Re: Z-15-005 - Laurel Hill Valley Citizen's Association Response

This document comprises the input of the response committee of Laurel Hill Valley Citizens to the zone change application submitted by the Schirmer-Satre Group on behalf of Environ-Metal, the developers of the previously proposed Laurel Ridge PUD.

Eugene-Springfield Metropolitan Area General Plan Proposed Plan Diagram

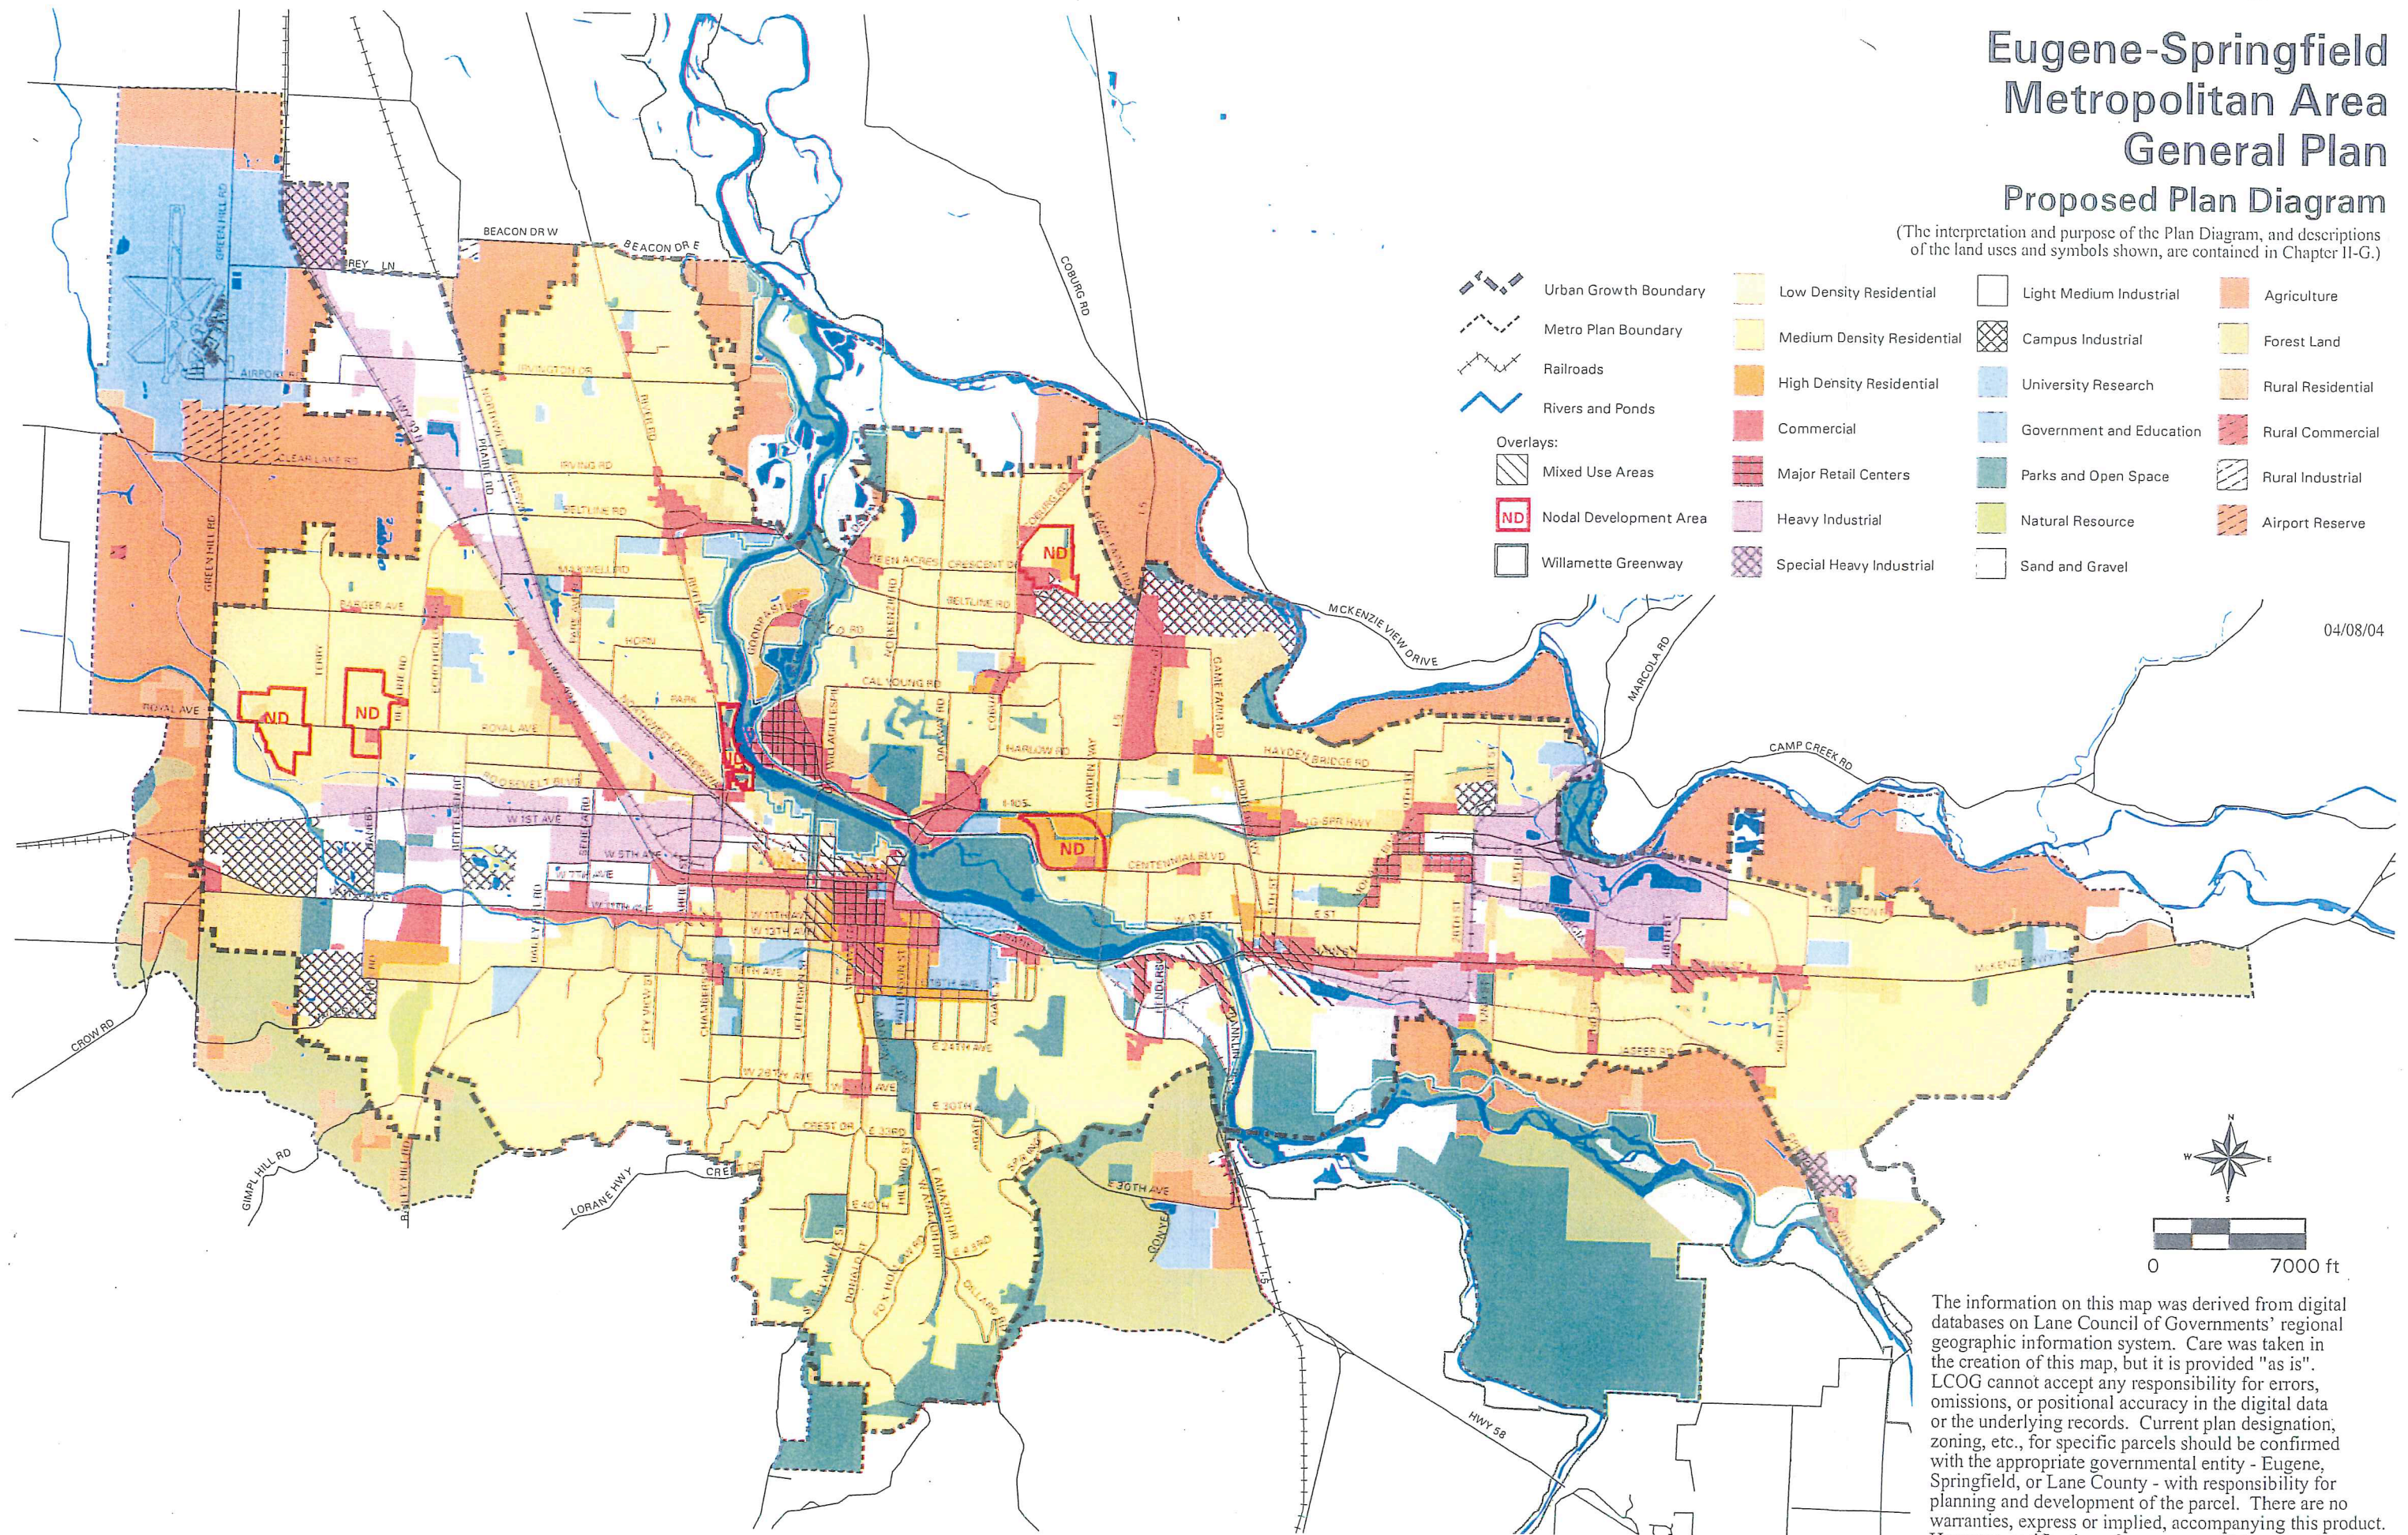
Consequently, as a result of this cartographic projection convention, the entire Metro Plan Diagram, as adopted by the City of Eugene in 2004, appears to be rotated clockwise by 2 degrees. On the original diagram, as presented in Exhibit C by the applicant (and following this page), the North Arrow (pointing to True North) is rotated correspondingly.

However, on the version of the Metro Plan currently displayed at the link to LCOG from the City's website (<http://www.lcog.org/DocumentCenter/View/144>), the north arrow is pointing straight up. This version was in place at the time Schirmer-Satre submitted their application in May of 2015.

Why and how does this matter for the issue of determining the area of POR zoning on the Laurel Ridge PUD property? It matters only because Schirmer-Satre chose the north arrow on the diagram as one of two "referents". This seemingly minor rotation results in a significant decrease of the area of POS zoning designation on the property.

ZC-2

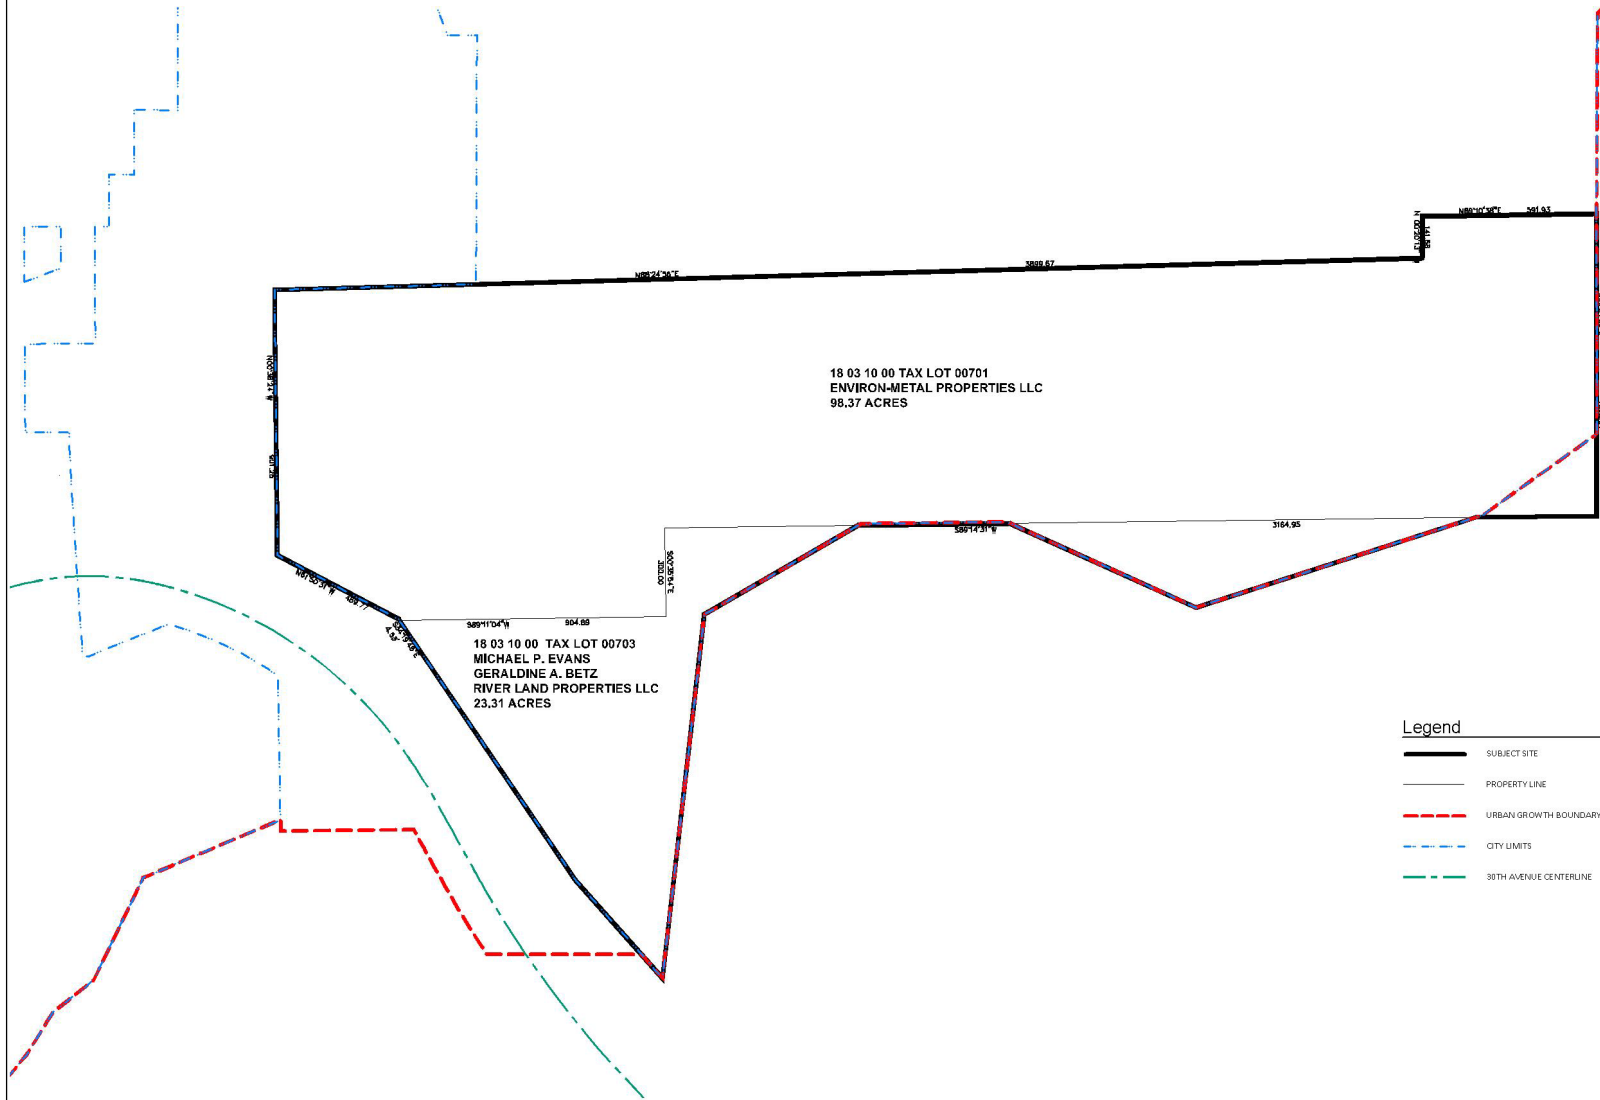
According to the notations on the tax lot map (and the applicant's maps), the almost 3,900-foot long western segment of the north property line of the Laurel Ridge property runs N 88°24'56" E. If the tax lot on the Zone Change application maps were rotated 2 degrees to match the Metro Plan Diagram, the orientation of this line should be the equivalent of 90°24'56" clockwise from a straight-up position, or just past the 3-o'clock mark on a watch. However, the north property boundary of the Laurel Ridge property is shown on Schirmer-Satre maps in a direction which implies that True North is straight up - it is shown significantly shy of the 3-o'clock position on a watch. Similarly, along with the tax lots, the City Limits and UGB layers of the applicant's maps are oriented to True North, and, it is assumed that the 30th Avenue R-o-W centerline is oriented to the same datum (see also applicant's Sheet ZC-2, next page).

However, the applicant did not rotate the Layers of the Metro Plan Diagram shown on their Sheet ZC-3 to coincide with True North. The applicant retains the 2-degree rotation imparted by the State Plane Coordinate System projection on their site maps only for selected layers of the Metro Plan, including the crucial Zoning Designations.

As a result, given that the applicant "pins" the Laurel Ridge property at the western end of the map by registration with 30th Avenue, the eastern portion of the site rotates a significant distance northward relative to the zoning map, thereby reducing the width and area of the POS zoning designation. The total reduction in POS achieved by the applicant versus the previously presented LCOG map is right around 8 acres

Applicant's Sheet ZC-4 at 50% Transparency

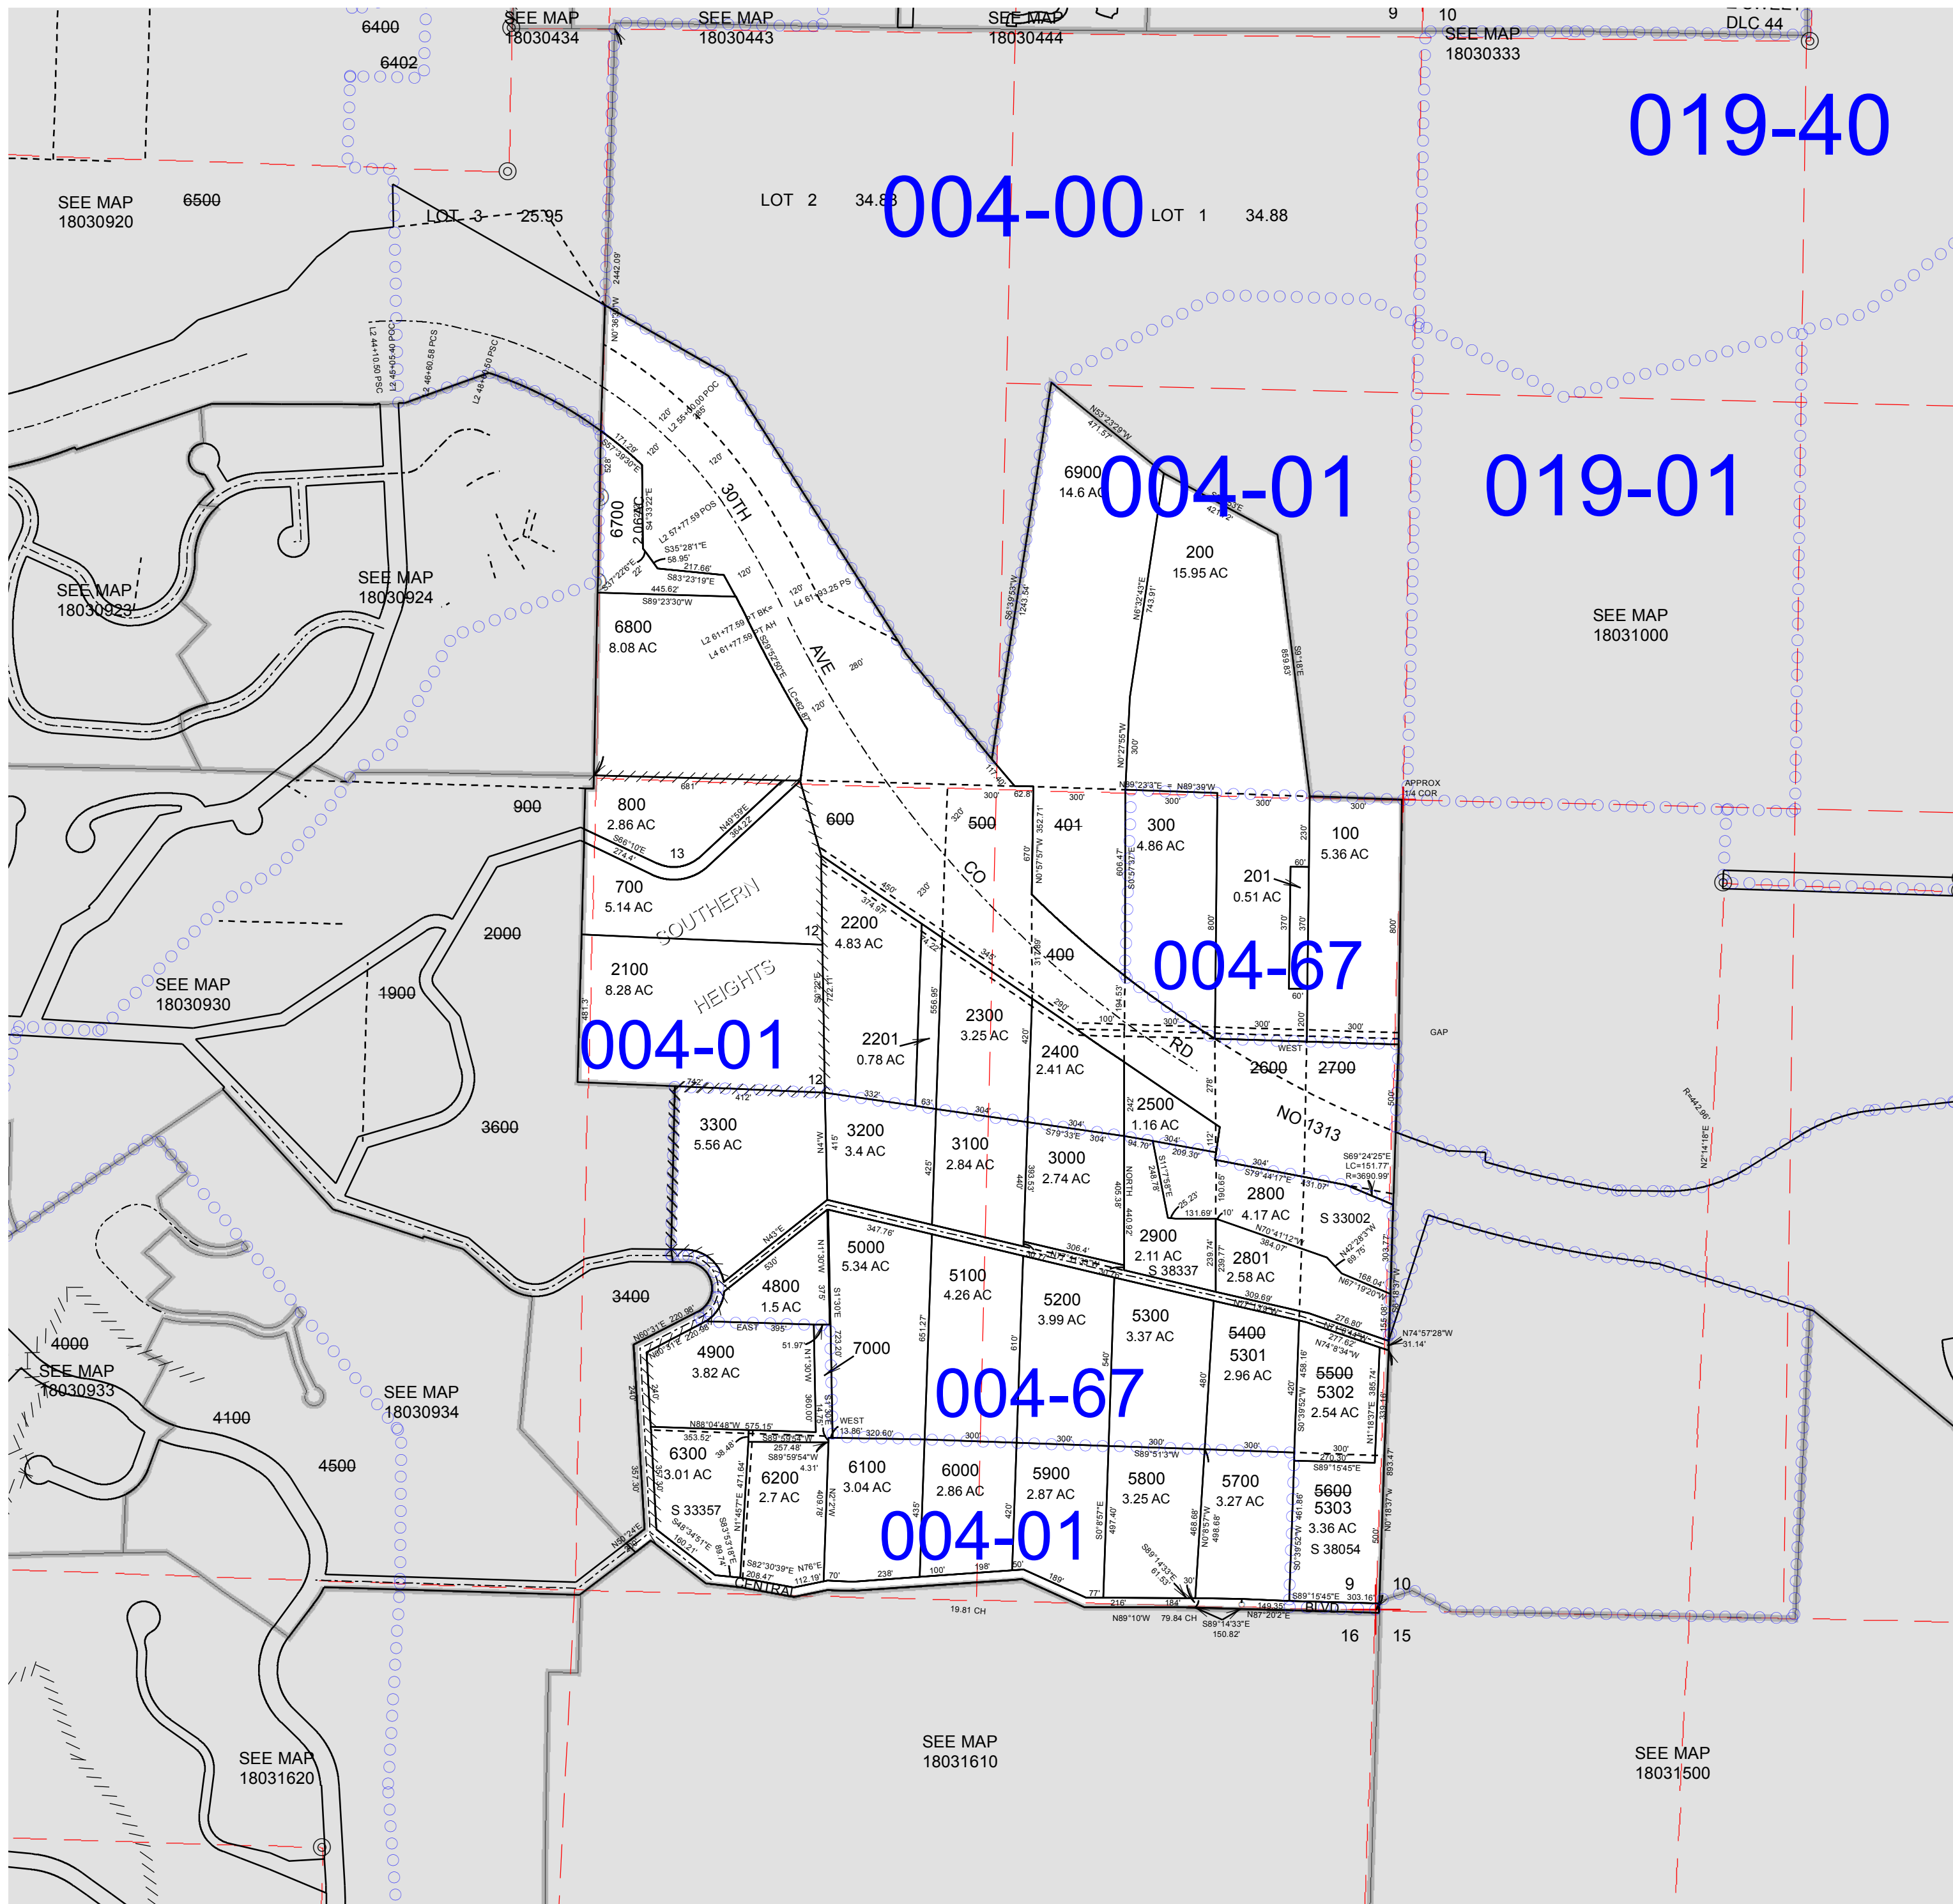
As shown in the figure on the following page, this offset is caused by the fact that in the western portion of the diagram, the applicant has moved the tax lot, city limits, UGB, and road centerline layers 179 feet to the northwest (N 58°W) relative to the equivalent position on the maps as supplied by LCOG. In the eastern portion, the offset direction is more northerly due to the effect of the 2-degree rotation. The following figures show a sequence of overlays of different transparency (0% - 50% -100%) of versions of the Tax-Lot-Layer-on-Metro-Plan-Diagram obtained from LCOG vs. the applicant's version on their sheet ZC-4.

In light of these obvious differences, the question that must be answered which map version is correct, or, more precisely, more correct. Even if the rotation issue is ignored, the Schirmer-Satre version of the tax lot overlay onto the Metro Plan Diagram is clearly significantly different (by 179 feet) from that used by LCOG and the City. However, simply the fact that LCOG's version has been used for some time now does not necessarily imply that it represents the "best" or "correct" way of overlaying the tax lot layer onto the Metro Plan diagram.

Schirmer-Satre uses a very small "snippet" of the Metro Plan diagram in isolation, in order to perform the alignment using only two referents (30th Avenue R-o-W centerline and north arrow). LCOG uses the entire diagram.

According to the tax lot map (Lane Co Map 18030900), in the vicinity of the Laurel Ridge property, the width of the right-of-way for 30th Avenue varies from 240 to more than 300 feet (there are even wider R-o-Ws in the area of the Spring Boulevard interchange). This is, comparatively, a very large right-of-way and poorly defines the actual location of the road. As a result, use of this referent imparts a very large measure of "slop" into the alignment of the diagram with the tax lot layer. In addition, in this area, the road surface itself is located close to the western boundary of the R-o-W as the eastern portion of the R-o-W is taken up by road embankments. Aligning the centerline of the R-o-W with the center of the road moves the R-o-W centerline significantly farther west than it is located in reality.
